LETTER OF SUBMITTAL
 KFM Skyway Project# 04-012024

Subject: USI - Documents Clearing W M NCR #68 (METS 54)

Subject: USI NCR No. 54: Failure to Submit A Critical Weld Repair Report Prior to Removing Weld Joints on Pa19

QUALITY ASSURANCE - NONCONFORMANCE REPORT

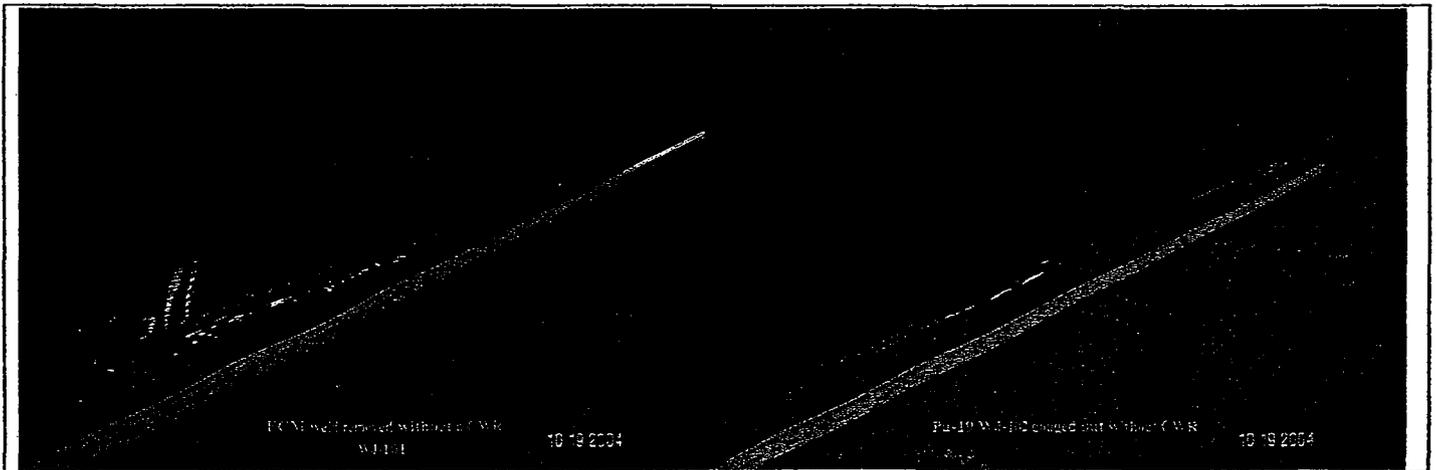
Description of Non-Conformance: Weld joints 101 and 102 on Pa-19 were gouged out without submitting a Critical Weld Repair for approval from the Engineer. The weld was removed in an attempt to straighten distortion from prior welding. The length of the excavation exceeds the allowable lengths in AWS D1.5, 1996, Section 12.17.2.

Applicable reference: AWS D1.5-96 Sec. 12.172 and 12.173

CWR# 04-80

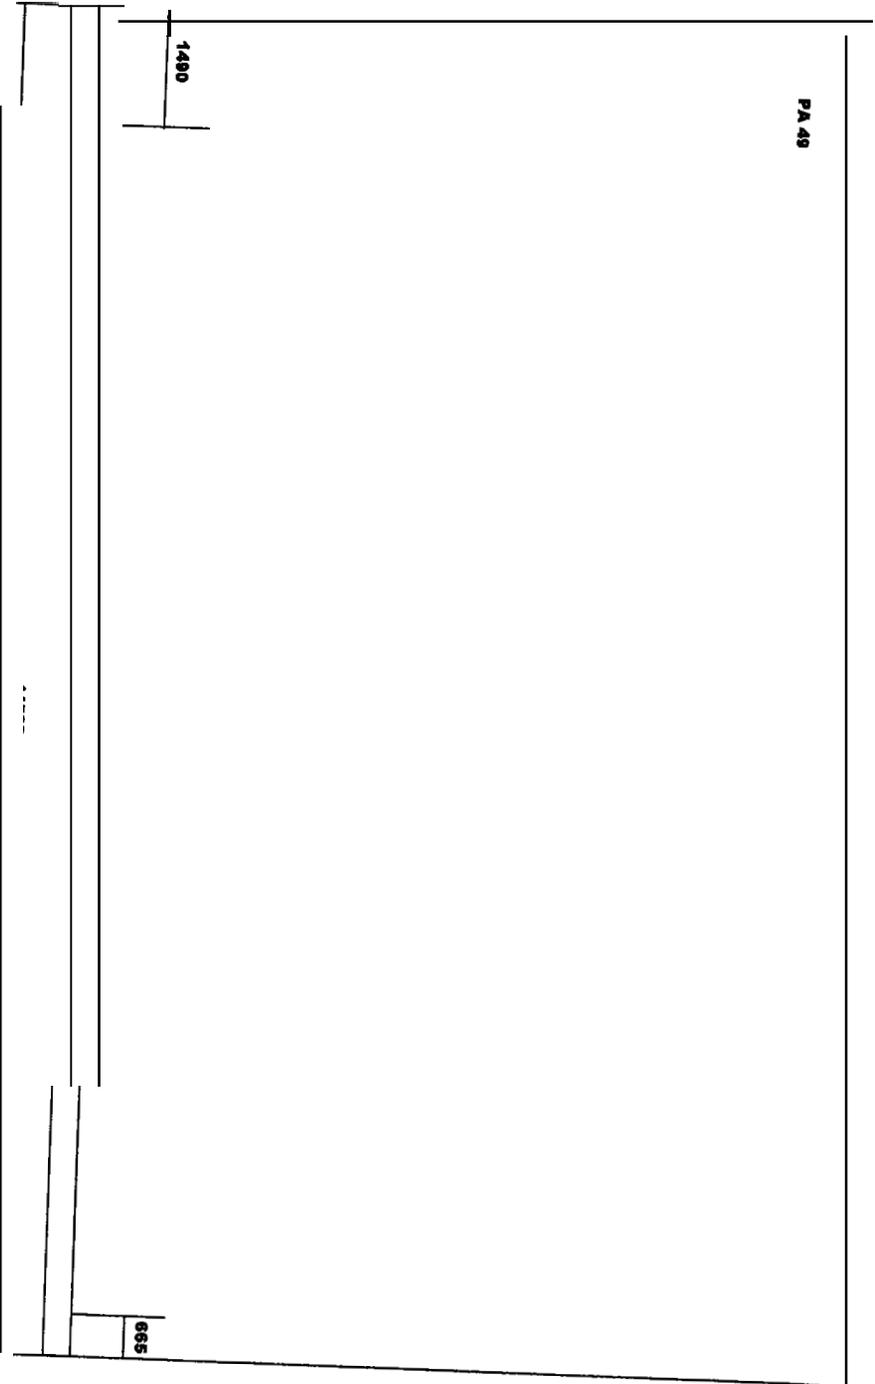
The Engineer **has** reviewed **KFM-SUB-003114R00: USI Critical Weld Repair Report 04-80** regarding the request to repair weld joint #101 between pa19 and pa49. The subject submittal is approved **with concerns**. **As** described in State Letter No. **5903**, the Engineer is concerned the Contractor began the requested repair prior to **obtaining** Engineer approval. The Engineer's approval is required prior to **beginning** all Critical Weld Repairs.

DATE:	INITIATOR	DEPARTMENT:	CWR NUMBER:
October 20, 2004	Ralph Seeley	Production	04-80
JOB NUMBER:	JOB NAME:	DRAWING	CODE/SPECIFICATION
23932	SFOBB	A3A/G	AWS D1.5
NONCONFORMANCE:			
<p>As shown on the attached USI-QC Weld Repair Tracking Sheet #0109, On girder 3A, pa19 to pa49 weld joint #101 weld was removed to repair weld distortion. A skip weld technique will be used to minimize weld distortion. This is a critical repair due to the length of the indication exceeds the length allowed. The location and size of the indication is illustrated on the attached sketch.</p>			
RECOMMENDED DISPOSITION:			
<ol style="list-style-type: none"> 1. Preheat to 150 degrees F for excavation if CAC-A is used. 2. Begin excavation to make sure that no more than 65% is removed 3 Grind to clean metal. 4 MT excavation to confirm that no indications are present. 5 Inform QA that weld repair is commencing. 6 Preheat per work procedure number 9.01 rev 4. 7 Weld using a previously approved FCM WPS for this project, being careful to tie stop and starts. 8 Post heat per work procedure number 9.01 rev 4.
